**RE: Albuquerque RV & Boat Storage
2201 Vista Oriente St. NW
Grading and Drainage Plan
Engineer's Stamp Date: 05/20/19
Hydrology File: H09D030**

Based upon the information provided in your submittal received 05/20/19, the Grading and Drainage Plan **is not** approved for Building Permit and SO19 Permit. The following comments need to be addressed for approval of the above referenced project:

Date: 05-17-19	No. Revision:	Date:	Job No. 2278
Drawn By: BJB			CG-102
Ckd By: FCA			SH. OF

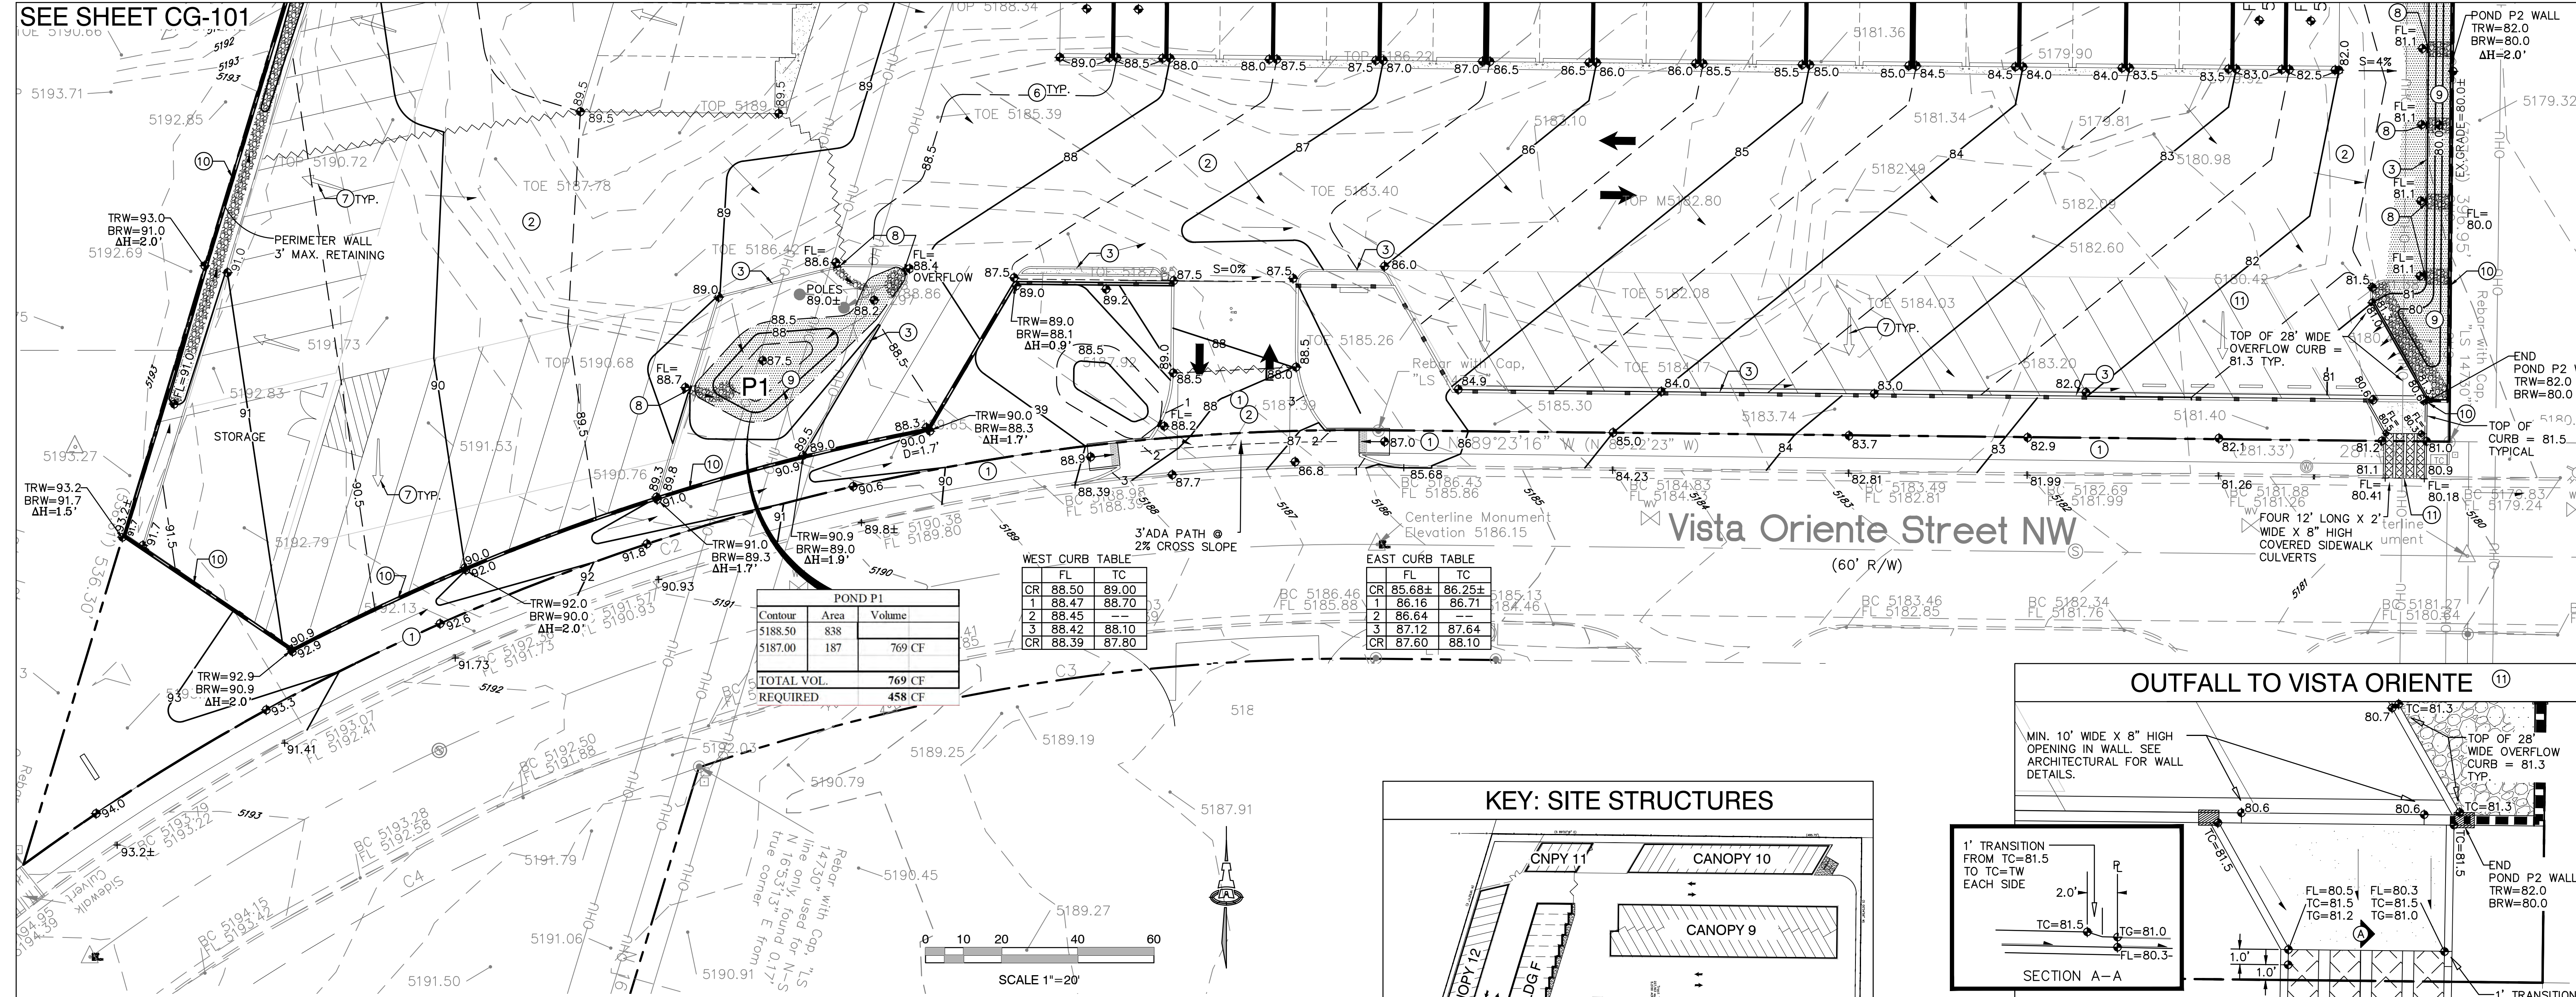
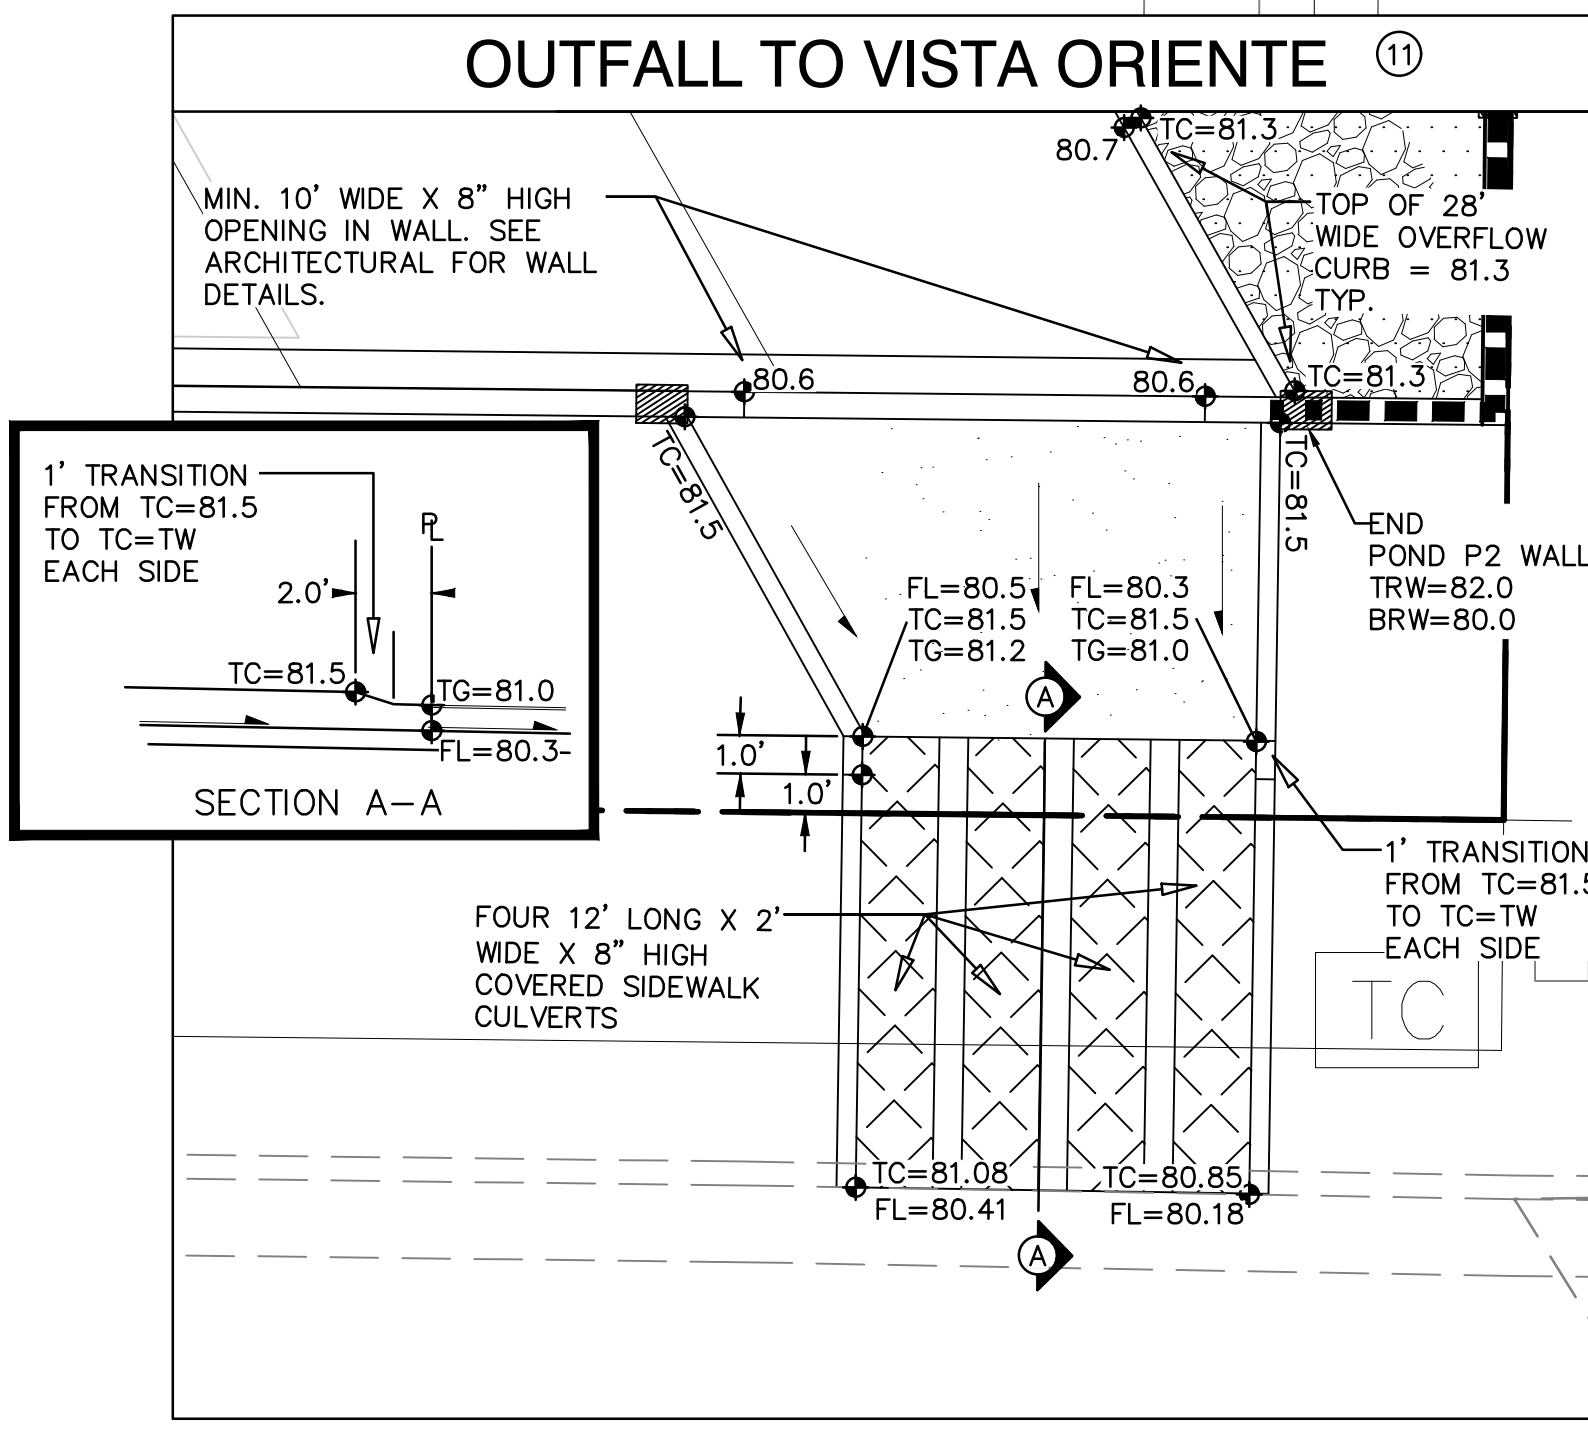
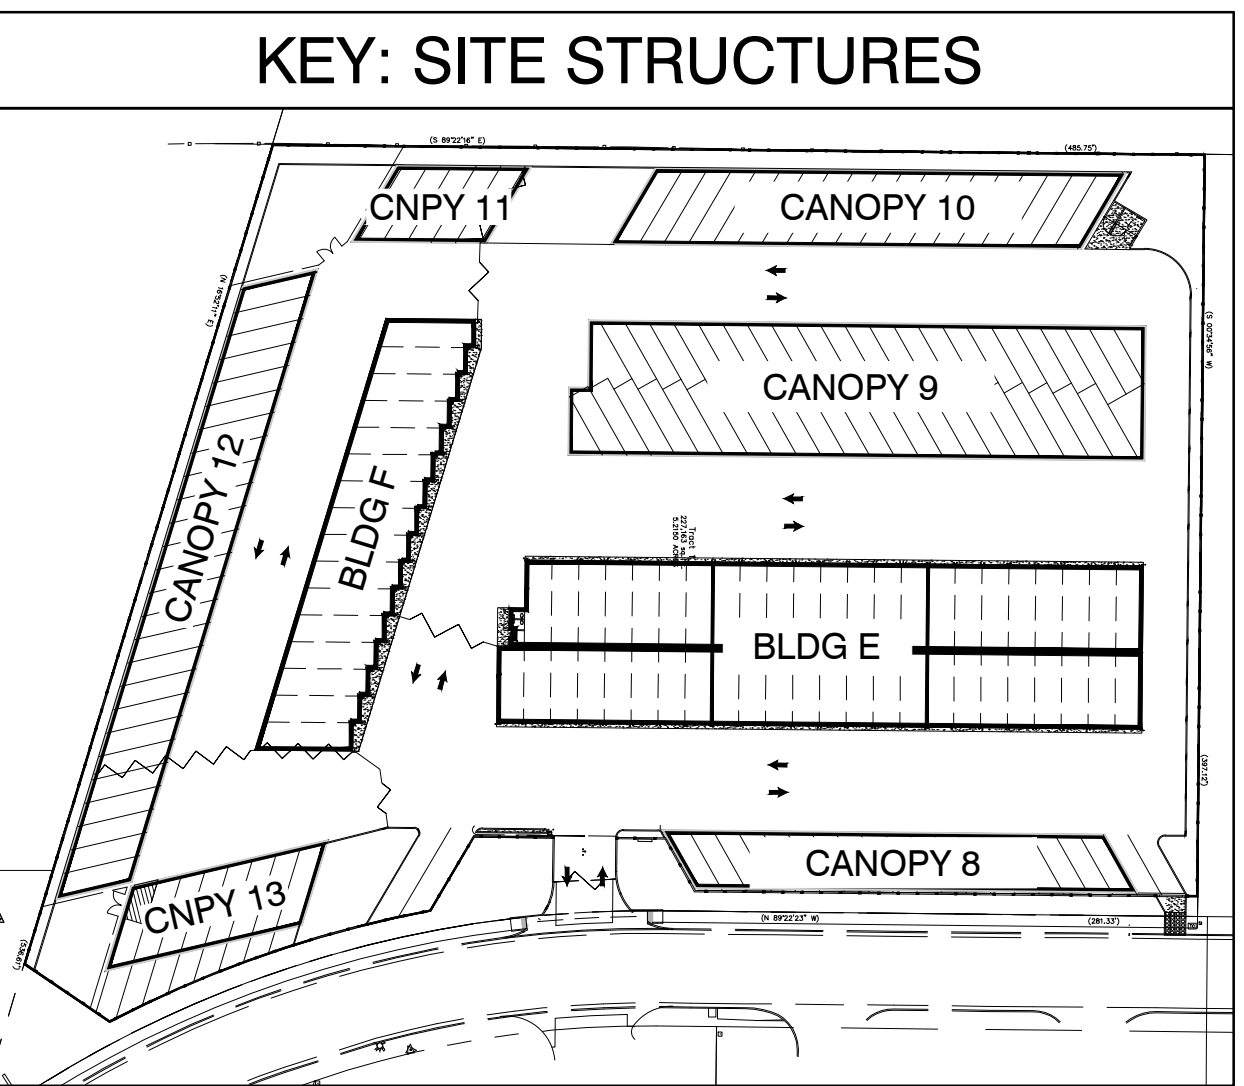
1. Please add sections of the proposed perimeter wall on the West and North property lines. This section should include the proposed perimeter wall along the property line, the proposed gravel swale, the location of the wall's footer (this needs to stay within the property) and the proposed grades on the other side of the wall.

2. Please add the reference to the City of Albuquerque standard detail No. 2236 for the sidewalk culverts.
3. Please correct the boarder on Sheet CG-101. It seems a little off.
